ATTACHMENT 3

40 queries relevant to water use
(Field Development Planning)

1-5. RIGHTS OF GROUNDWATER USERS

5-37. RISKS TO SIGNIFICANT SPECIES IN SPRINGS AND WATER COURSES

Figure 1: Location of monitoring wells (Jacobs (Australia), 2020)

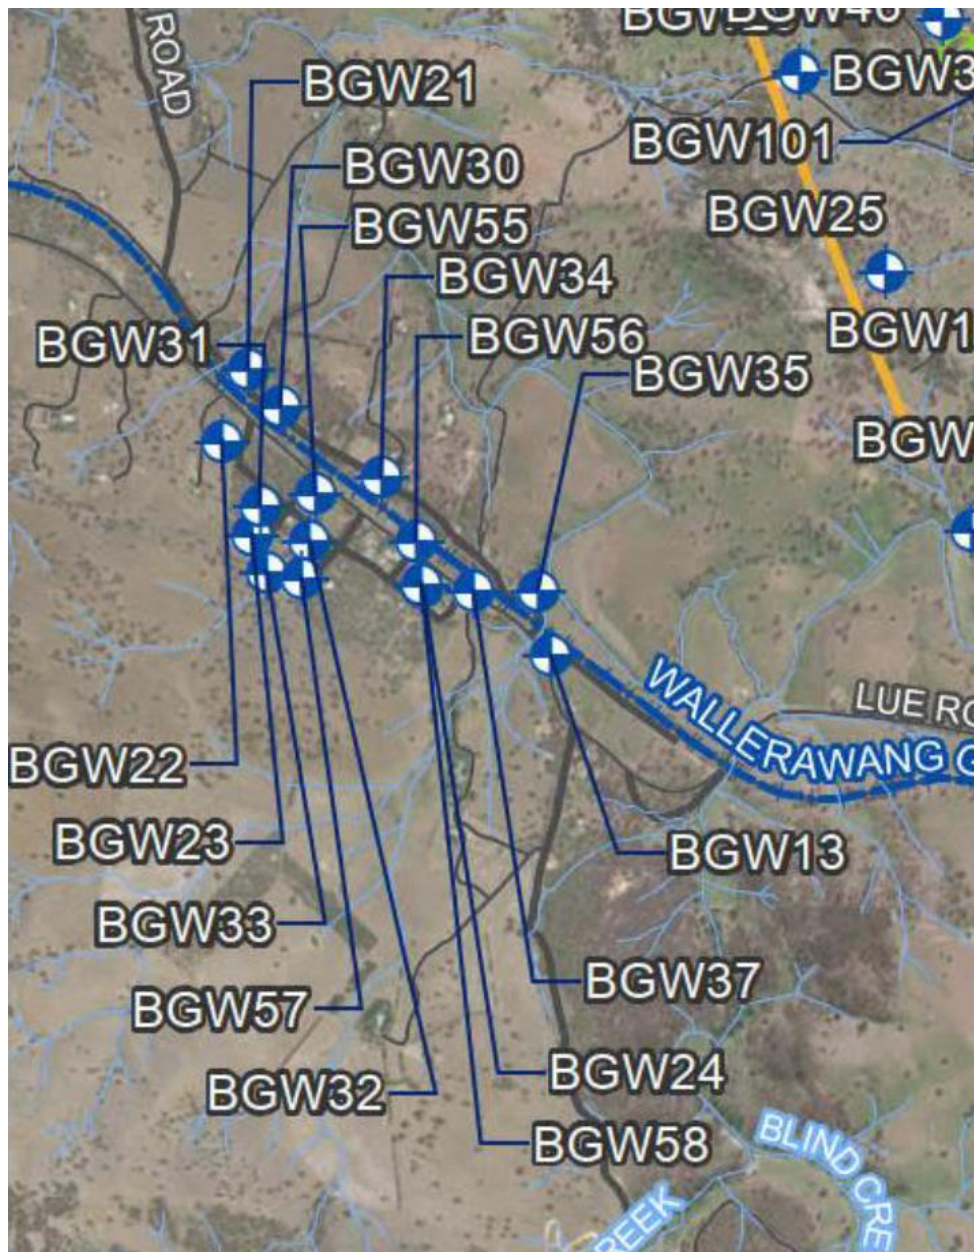
The monitoring bores reported in the EIS located within 1.5 km of Lue are shown in Table 1. The *NSW Aquifer Interference Policy 2012* requires baseline groundwater conditions to be established. It also requires quality impacts from licensed water users of connected groundwater to be established.

Despite conclusions portrayed in Table 22 (Jacobs (Australia), 2020, pp. 5-110), there is no evidence of non-potable water quality in bores in Lue from the sampling undertaken (Table 1).

Table 22 (Jacobs (Australia), 2020, pp. 5-110) indicates the following exceedances for ADWG, however, these appear to be errors requiring explanation as highlighted in Table 1 above:

- BGW21 manganese: 11 samples reported below 0.2 mg/L (average of 0.064 mg/L), well below the 0.5 mg/L ADWG limit. The 12th sample on 01 May 15 reported 31.1 mg/L
 - No comment provided on whether the single 31.1 mg/L reading led to the average being >0.05 mg/L, or whether it is simply an error
 - If the 01 May 15 reading is considered, the mean is 2.650 mg/L not 1.354 mg/L (greater than ADWG) as reported in the EIS
- Average arsenic concentrations for BGW32, 33, 35 and 37 are reported as >0.01 mg/L (above ADWG) in Table 22, however, no individual analyses >0.01 mg/L are reported:
 - BGW32: Arsenic <0.002 mg/L on 09 Jan 14 and 08 April 14
 - BGW33: Arsenic <0.002 mg/L on 09 Jan 14, 08 Jul 14 and 25 Feb 16
 - Similar analyses for BGW35 & 37

Figure 1: Suggested cross section transects for the EIS and surface geology (Source: Geoscience Australia)

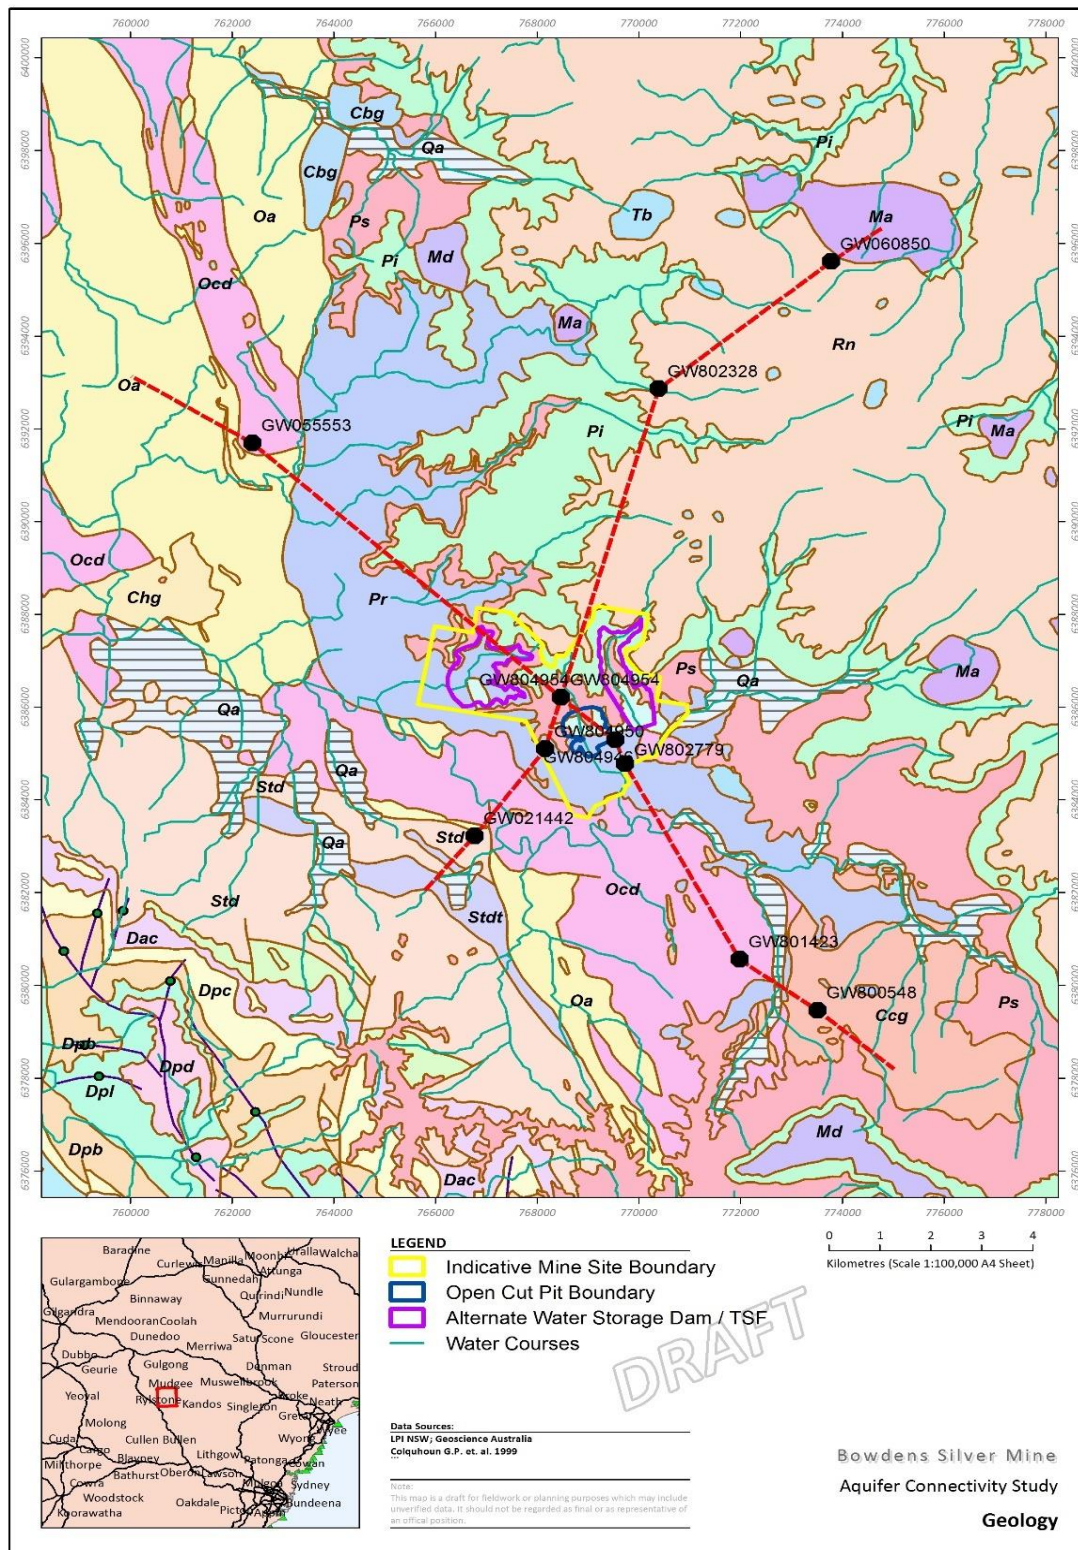
When this information is compared to the EIS interpretation (Figure 2) and while faulting can be inferred, the mapped outcrop of Late Ordovician-Early Silurian age Ocd (Coomber Formation) near Lue village north west of GW021442 is not presented in the EIS. Suggested cross section transects are shown in Figure 1.

Figure 2: West-east modelled cross section. Source: Adapted from Figure 51 from (Jacobs (Australia), 2020, pp. 5-143)

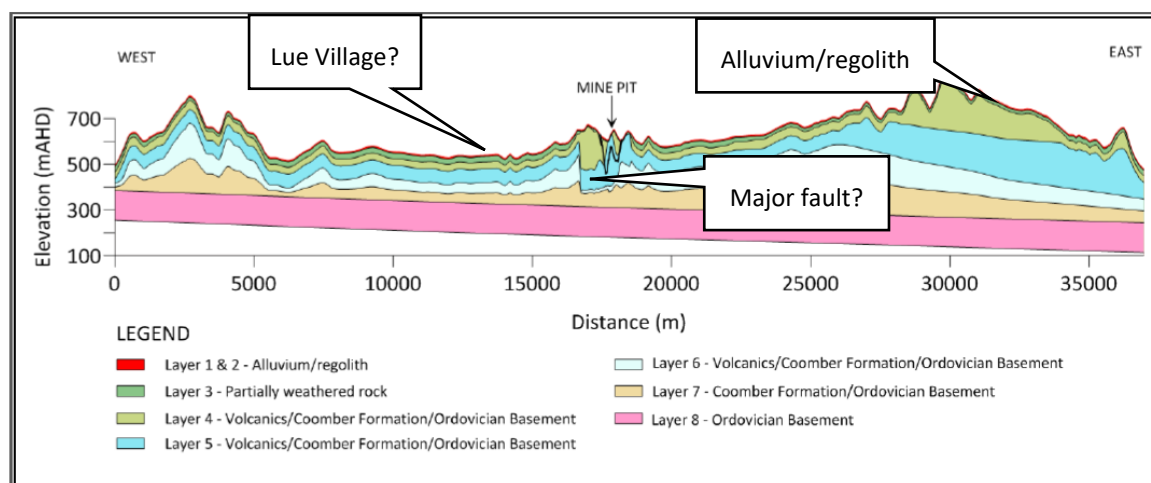
This discrepancy (a lack of Ocd outcrop on Figure 2) highlights an area for future focus to adequately represent the hydrogeology in the alluvium near Lawsons Creek proximal to Lue Village bores and the associated significant species.

Without a good hydrogeological understanding, the assumptions used in the impact assessments regarding impacts to springs and watercourses in the EIS may be invalid. This is an example of how the significance of the assumptions underpinning the large-scale simulation modelling should be better explained in the EIS to make it effective if it is to be used at the local scale. In addition, studies of unique or endemic species of gaining wetlands (springs) should be undertaken to determine their significance.
